UNITED STATES PATENT AND TRADEMARK OFFICE

| APPLICATION NO. | FILING DATE | FIRST NAMED INVENTOR | ATTORNEY DOCKET NO. | CONFIRMATION NO. |
|-----------------|-------------|----------------------|---------------------|------------------|
| 09/803,563 | 03/09/2001 | Raimond Lasar | 01LASR01PN | 7303 |

Office Action Summary

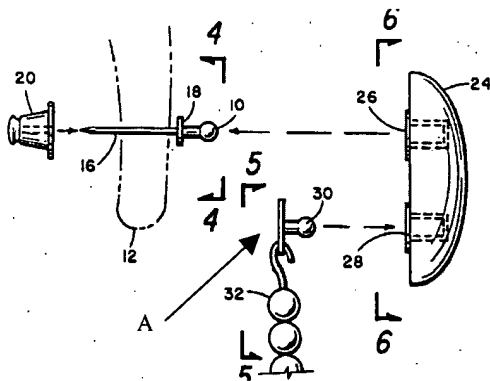
7. Claims 1, 14, 15, and 21 are rejected under 35 U.S.C. 102(b) as being anticipated by Hernandez (U.S. Patent No. 4,783,974). Hernandez discloses a body decoration system as claimed; wherein said system comprises a body piercing section (16), said body piercing section having a primary end, a secondary end (10), and a diameter; a fastening section (20), said fastening section having a diameter, said diameter of said fastening section being greater than said diameter of said body piercing section, a primary attachment, said primary attachment of said fastening section being detachably related in mating engagement with said primary end of said body piercing section; a head section (24), said head section having a secondary attachment (26), said secondary attachment of said head section being attached to said secondary end of said body piercing section, a primary attachment (28), said primary attachment of said head section

providing a detachable mating engagement; and a decorative section (A), said decorative section having a primary attachment (30), said primary attachment of said decorative section being detachably related in mating engagement so said primary attachment of said head section, a decorative element (32), said decorative element being affixed to said primary attachment of said decorative section; whereby said decorative section may be removed and replaced with a different section without removing said head section or said fastening section from said body piercing section, see figure below.

As it concerns claim 14, Hernandez's fastening section (20) is essentially spherical. Regarding claim 15, said body piercing section (16) is a piercing pin.
